Application by Light Valley Solar Limited for the Light Valley Solar project

The Examining Authority's written questions and requests for information (ExQ1): Issued on 22 September 2026

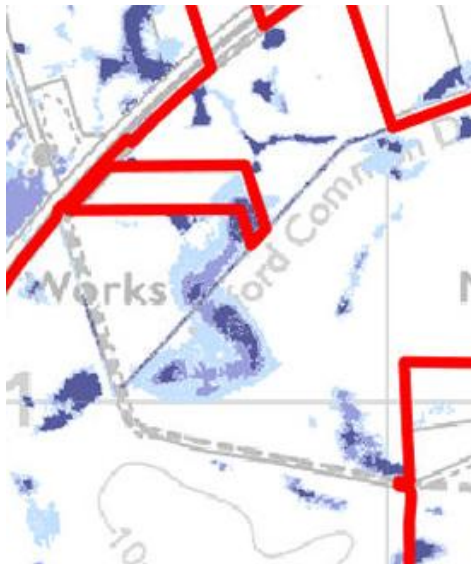
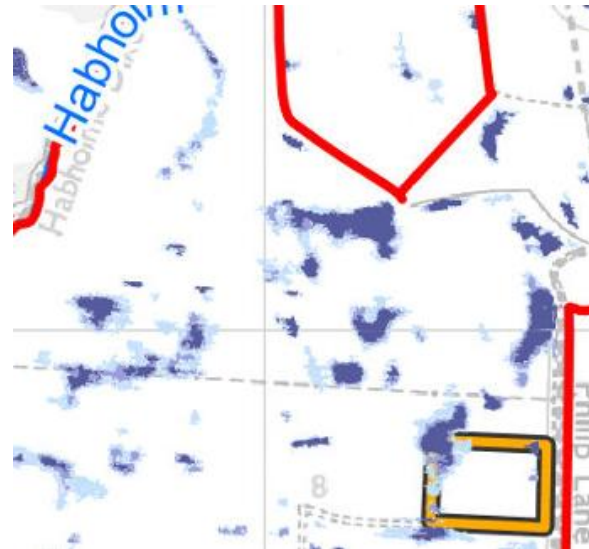
15. Water environment (including Water Framework Directive Assessment and Flood Risk Assessment)		
Flood risk		
Q1.15.1	The applicant	The risk from surface water flooding to the development Paragraph 6.2.18 of the FRA [REP2-079] explains the risk from surface water flooding would be “managed through the detailed siting and design of infrastructure, including by applying the committed Design Principle of 10m from the bank top of all watercourses, minimum panel ground clearances, and the minimum finished floor level and freeboard requirements for flood-sensitive assets”. ES Figure 15.9 [REP2-054] identifies areas of SDS3, SDS4, SDS6, SDS7 and SDS8 at risk of surface water flooding which may be deeper than 0.4m (the minimum panel ground clearance secured in the DPC [REP2-021]) and greater than 10m away from the bank top of watercourses. The applicant is therefore to confirm if solar panels would: • not be sited in these locations as suggested in the FRA • be raised above the identified risk of surface water flooding as suggested at ISH1, and if so, what height that would be • be allowed to flood? The extracts from ES Figure 15.9 below are provided as examples to illustrate this risk.
